8.4 DA 2015/138 - Coastal Protection Works, Skinner and Camden Streets**8.4 DA 2015/138 - Coastal Protection Works, Skinner and Camden Streets**

Applicant	Civiltech Consulting Engineers
Property	Lot 10 DP 1126929, Lot 1 DP 1119099, Lot 3 DP 1079380, No. 2 Skinner Street and Nos. 3 & 5 Camden Lane, Ballina
Proposal	To undertake coastal protection works comprising a dry rock revetment wall and partial filling of land behind the revetment wall within the subject lands
Effect of Planning Instrument	The lands are zoned R2 Low Density Residential and W1 Natural Waterways under the provisions of the Ballina LEP
Locality Plan	The subject lands are depicted on the locality plan attached

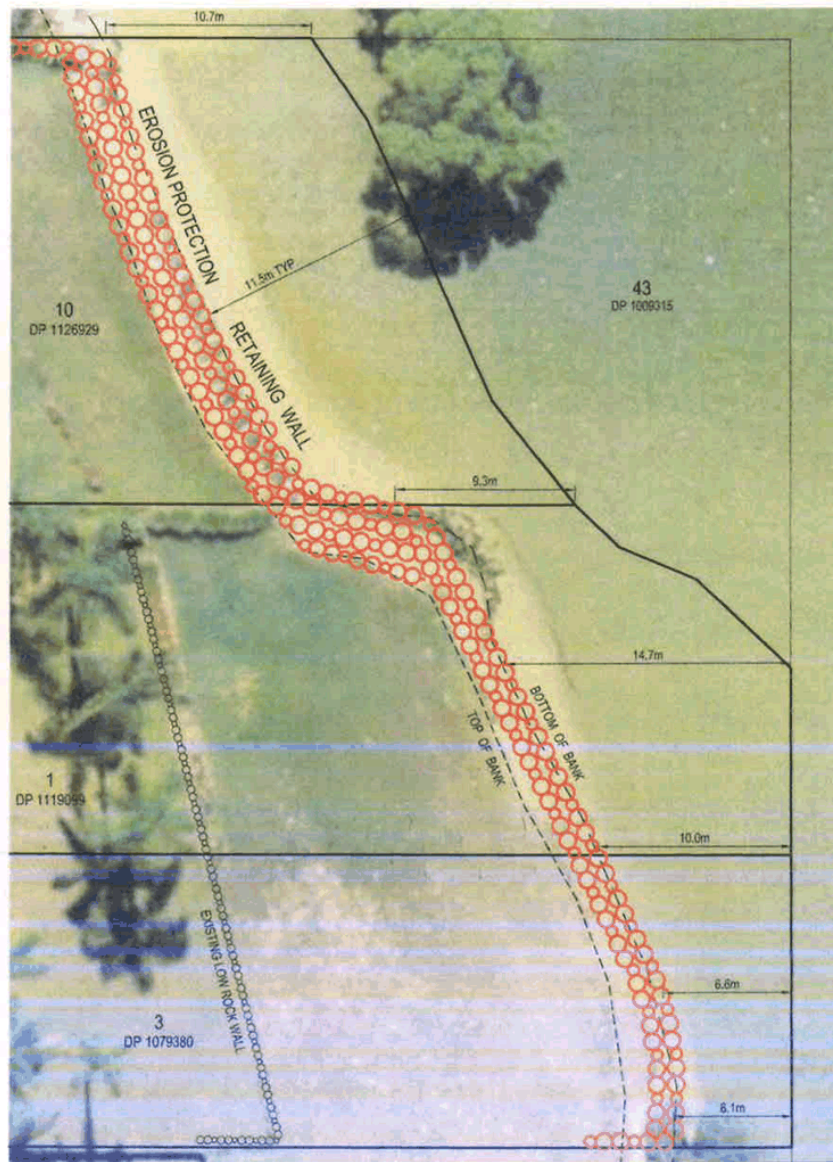
To clarify two issues I have had prepared a survey plans.

The report to Council claimed that there was no evidence of the need for erosion protection . Attached is a plan showing the position of the bank before the 2009 weather event and as at today . You will observe that the shift in the bank is a maximum of 14.7 metres down to 6 metres .

The plan also plots the levels at the foot of the bank and the western boundary of Norton Street . You will observe that the difference is 9 mm .

There would be no discernible difference in the water levels as the tide came in . The main factor would be wind direction .
